Environmental Impact Statement for the Proposed National Enrichment Facility in Lea County, New Mexico

Appendices H through J

Final Report

**U.S. Nuclear Regulatory Commission
Office of Nuclear Material Safety and Safeguards
Washington, DC 20555-0001**

Figure E-8 Average 24-Hour Concentrations of Pollutants in Extreme Winds from the West-Southwest

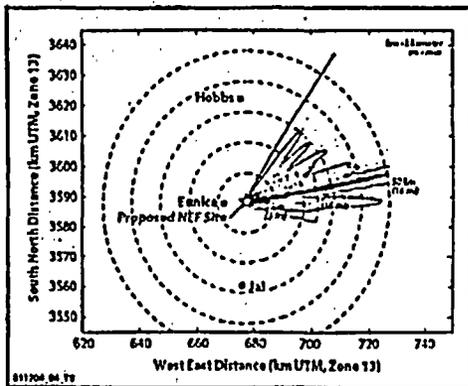
94. Page E-4, lines 64 and 65 - This sentence refers to Figure E-8 and states "This figure shows that a narrow plume would extend to the west from the proposed NEF source." However, Figure E-8 shows the plume extending to the east of the NEF site. Therefore, the sentence should be revised to "This figure shows that a narrow plume would extend to the east from the proposed NEF source." Comment #048-97
